NUMBER
DEP16588

LINE	QUANTITY	UOP	CAT. NO.	ITEM NUMBER	UNIT PRICE	AMOUNT
ADDENDUM NO. 1						
ADDENDUM ISSUED:						
1. TO PROVIDE RESPONSES TO VENDOR'S QUESTIONS REGARDING THE ABOVE SOLICITATION.						
2. TO PROVIDE VENDORS A REVISED DRAWING AND A REVISED CONTRACTOR'S BID SHEET.						
3. TO PROVIDE VENDORS A COPY OF THE MANDATORY PRE-BID MEETING SIGN-IN SHEETS.						
4. TO MOVE THE BID OPENING DATE: FROM: 08/12/2014 @ 1:30 P.M. TO: 08/21/2014 @ 1:30 P.M.						
5. TO PROVIDE ADDENDUM ACKNOWLEDGMENT. THIS DOCUMENT SHOULD BE SIGNED AND RETURNED WITH YOUR BID. FAILURE TO SIGN AND RETURN MAY RESULT IN THE DISQUALIFICATION OF YOUR BID.						
END OF ADDENDUM NO. 1						
0001	1	JB		962-73		
RECLAMATION: RESTORATION OF LAND & OTHER PROPERTIES

SOLICITATION NUMBER: DEP16588
Addendum Number: 1

DEP16588
Amigo Portals
Addendum #1

Item 36: The drawing below should replace the relevant profile drawing on sheet 44 for a culvert type of bat gate without drain pipes (Detail 1/44).

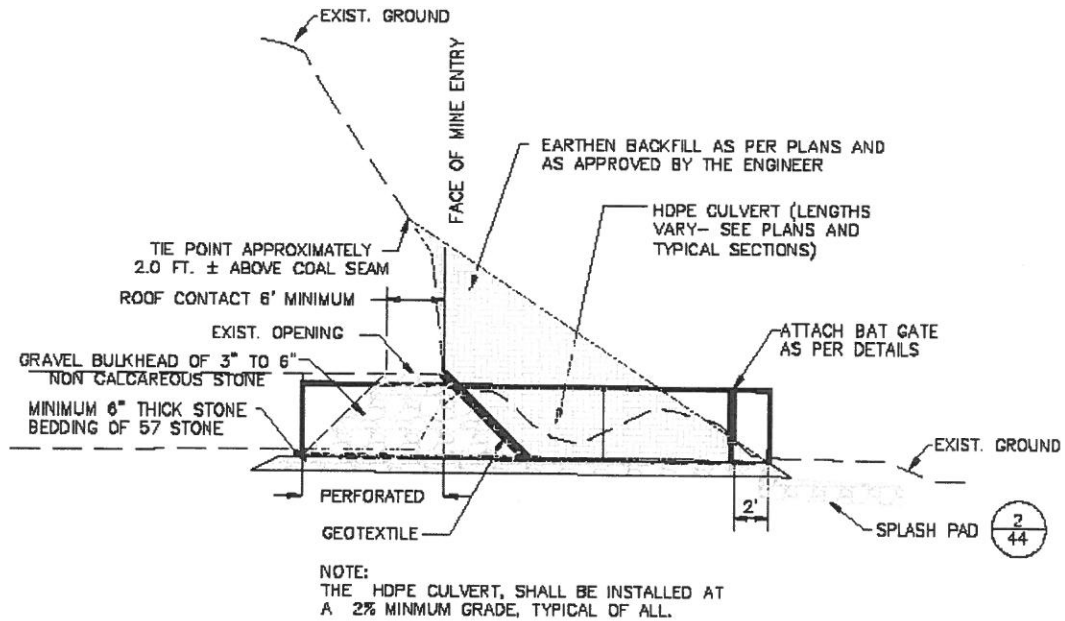
- Item 11: Q - Does this mine seal need a drain pipe, what is the length, and what grade is required? (Portal 2, Drawing 23.)
A - This portal has always been dry. Therefore, drain pipes have not been proposed. There is no desire to reclaim the highwall behind this portal. We are only concerned with the effective sealing of the mine opening. The backfill should be placed a minimum of 2 feet above the coal seam. The cover slope is 2H:1V. The minimum grade for the bat gate (HDPE culvert) is 2%.
Note: A revised detail has been included as Item 36 in this Addendum, and should replace the relevant profile detail on Drawing 44.
